The Commission has issued the enclosed Amendment No. ²⁸ to Facility Operating License No. DPR-71 and Amendment No. ⁵¹ to Facility Operating License No. DPR-62 for the Brunswick Steam Electric Plant (BSEP), Unit Nos. 1 and 2, respectively. These amendments consist of changes to the Technical Specifications in response to your applications dated October 25, December 27, 1976; July 28, 1977; January 18, February 2, March 6, March 21, April 13, April 27, May 1, May 29, October 8, November 7, December 31, 1979; February 5, February 20, April 1, April 11, April 22, May 21, and May 27, 1980.

The amendment for BSEP Unit No. 2 changes the Technical Specifications to establish revised safety and operating limits for operation in fuel Cycle No. 4, and revises the table of safety related hydraulic snubbers.

BRUNSWICK STEAM ELECTRIC PLANT, UNIT NO. 1

BRUNSWICK STEAM ELECTRIC PLANT, UNIT NO. 2

FIG. 3.2.1-1

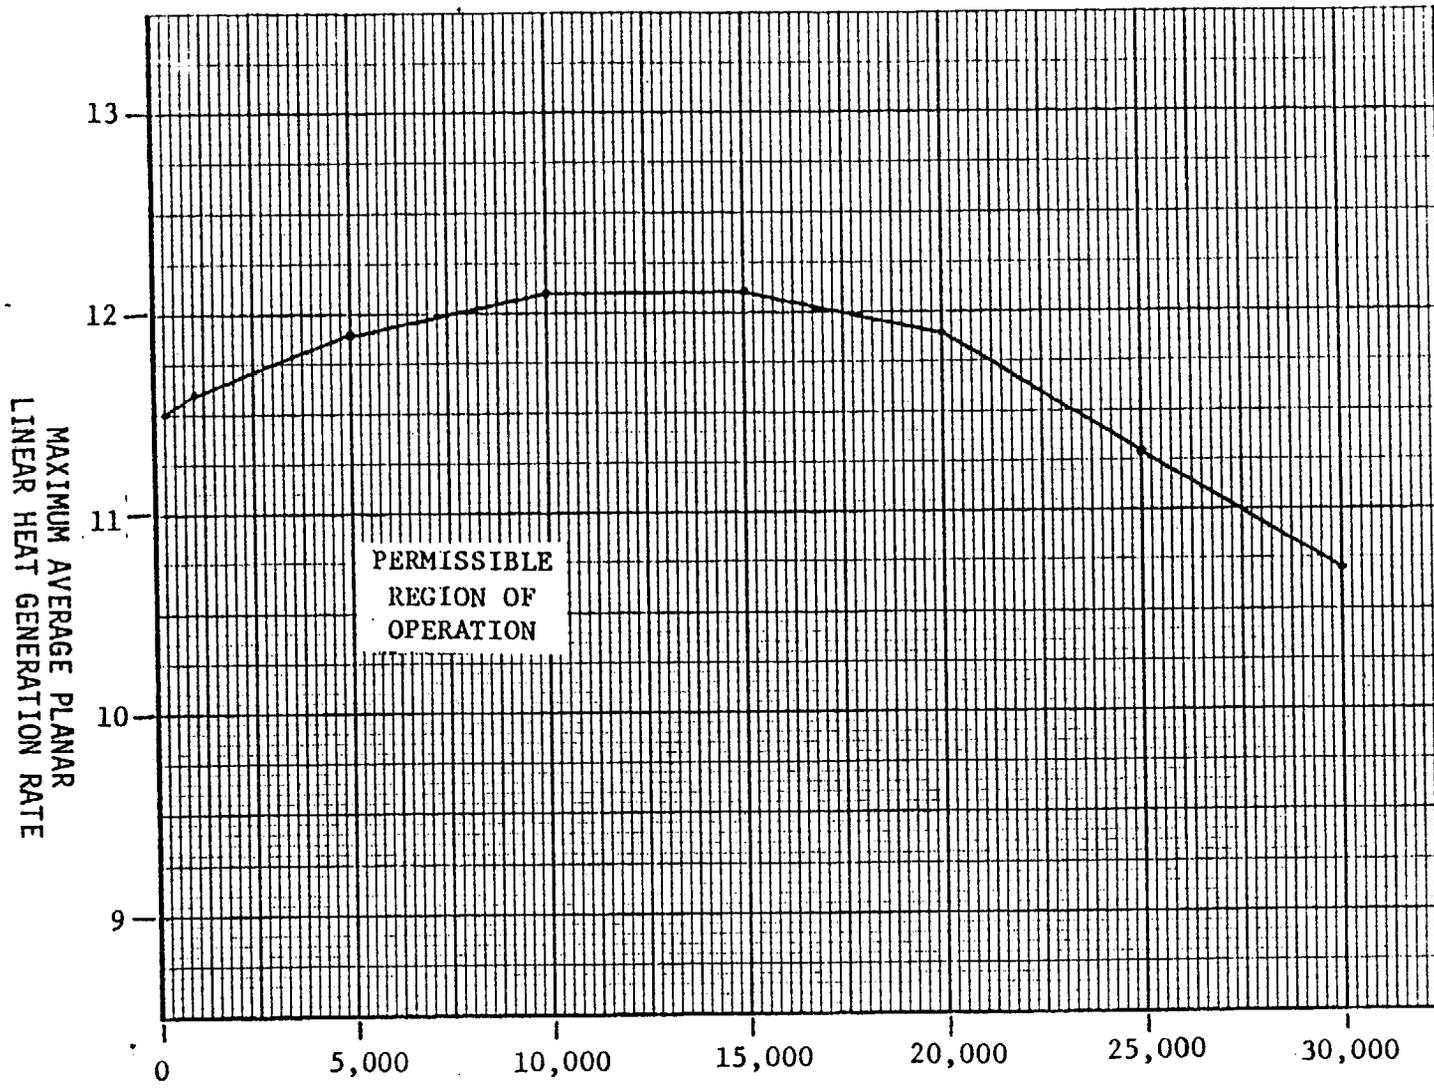
3.2.1 All AVERAGE PLANAR LINEAR HEAT GENERATION RATES (APLHGR's) for each type of fuel as a function of AVERAGE PLANAR EXPOSURE shall not exceed the limits shown in Figures 3.2.1-1, 3.2.1-2, 3.2.1-3, 3.2.1-4, 3.2.1-5, 3.2.1-6, 3.2.1-7 or 3.2.1-8.

With an APLHGR exceeding the limits of Figures 3.2.1-1, 3.2.1-2, 3.2.1-3, 3.2.1-4, 3.2.1-5, 3.2.1-6, 3.2.1-7 or 3.2.1-8, initiate corrective action within 15 minutes and continue corrective action so that APLHGR is within the limit within 4 hours or reduce THERMAL POWER to less than 25% of RATED THERMAL POWER within the next 4 hours.

FIGURE 3.2.3-1

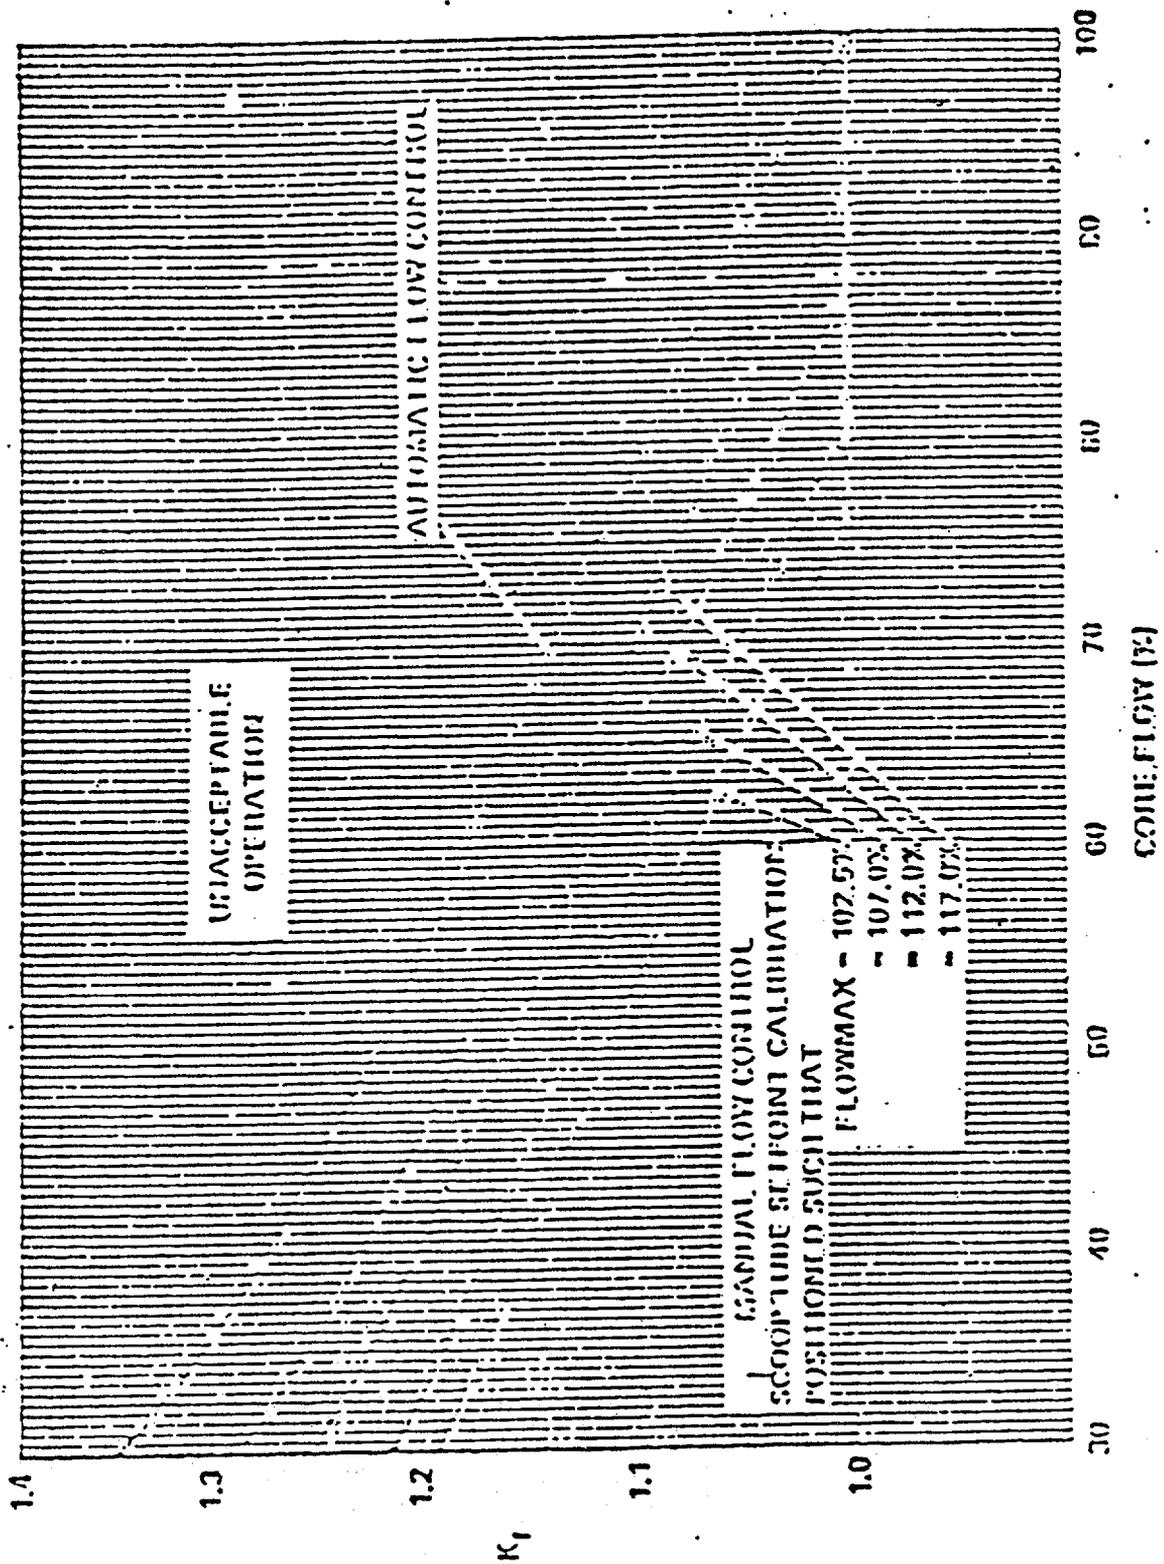
3.2.3 The MINIMUM CRITICAL POWER RATIO (MCPR), as a function of core flow, shall be equal to or greater than MCPR times the K_f shown in Figure 3.2.3-1, provided that the end-of-cycle recirculation pump trip system is OPERABLE per Specification 3.3.6.2, with:

1. Beginning-of-cycle (BOC) to end-of-cycle (EOC) minus 2000 MWD/t, within one hour determine that MCPR, as a function of core flow, is equal to or greater than MCPR times the K_f shown in Figure 3.2.3-1 with:

- a. MCPR for 7x7 fuel = 1.21,*
 - b. MCPR for 8x8 fuel = 1.28,
 - c. MCPR for 8x8R fuel = 1.21, and
 - d. MCPR for P8x8R fuel = 1.21.
 2. EOC minus 2000 MWD/t to EOC minus 1000 MWD/t, within one hour determine that MCPR, as a function of core flow, is equal to or greater than MCPR times the K_f shown in Figure 3.2.3-1 with:

- a. MCPR for 7x7 fuel = 1.21*
 - b. MCPR for 8x8 fuel = 1.28
 - c. MCPR for 8x8R fuel = 1.26, and
 - d. MCPR for P8x8R fuel = 1.28
 3. EOC minus 1000 MWD/t to EOC, within one hour determine that MCPR, as a function of core flow, is equal to or greater than MCPR times the K_f shown in Figure 3.2.3-1 with:

*For 7x7 fuel assemblies, the K_f factor is based on the 112% flow curve of Figure 3.2.3-1 rather than the actual setpoint of 102.5%.

FIGURE 3.2.4-1

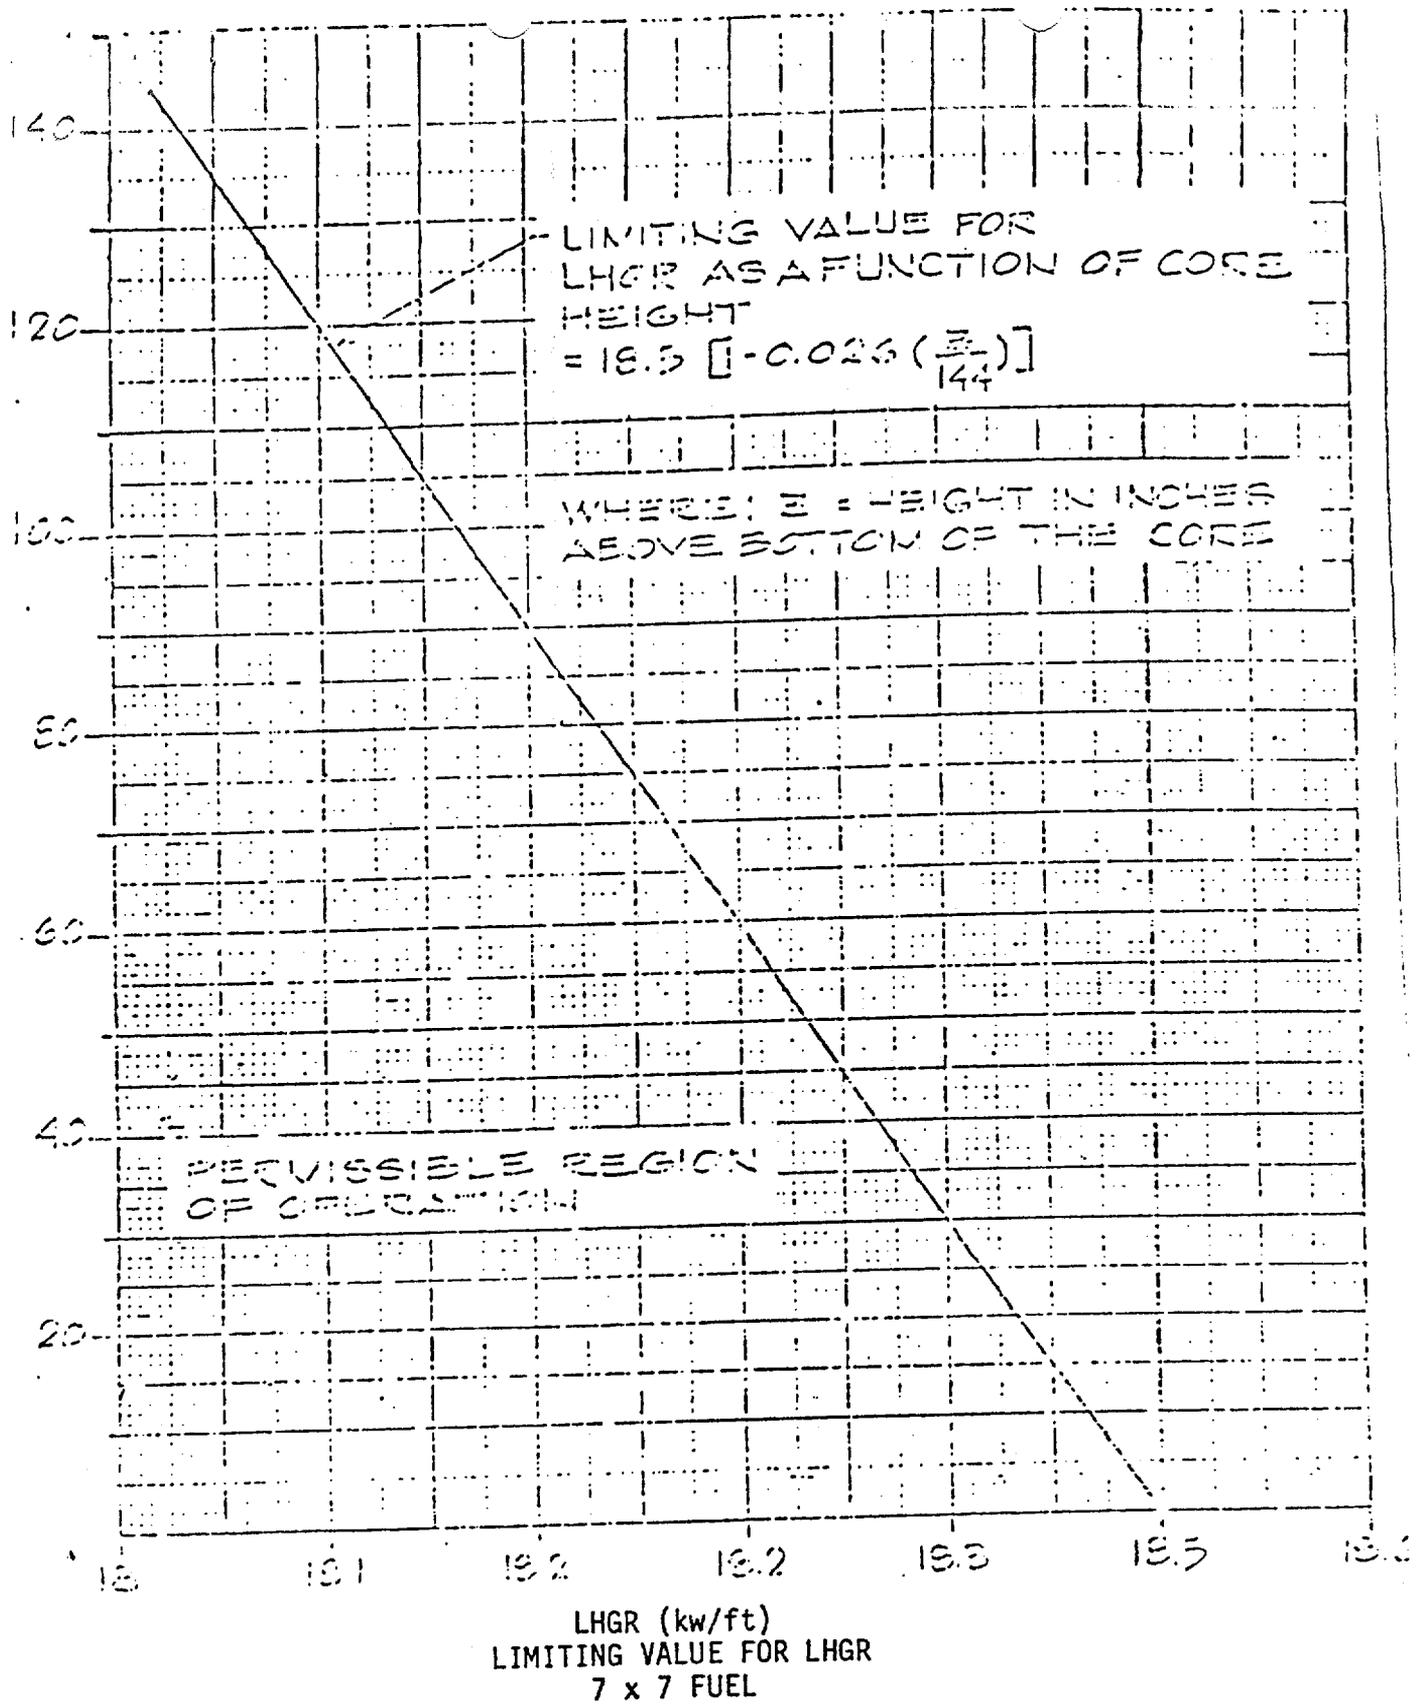
- a. For 7 X 7 fuel assemblies, as a function of core height for any fuel rod in an assembly, the maximum allowable LHGR shown in Figure 3.2.4-1.
- b. For 8 X 8, 8 X 8R and P8 X 8R fuel assemblies, 13.4 kw/ft.
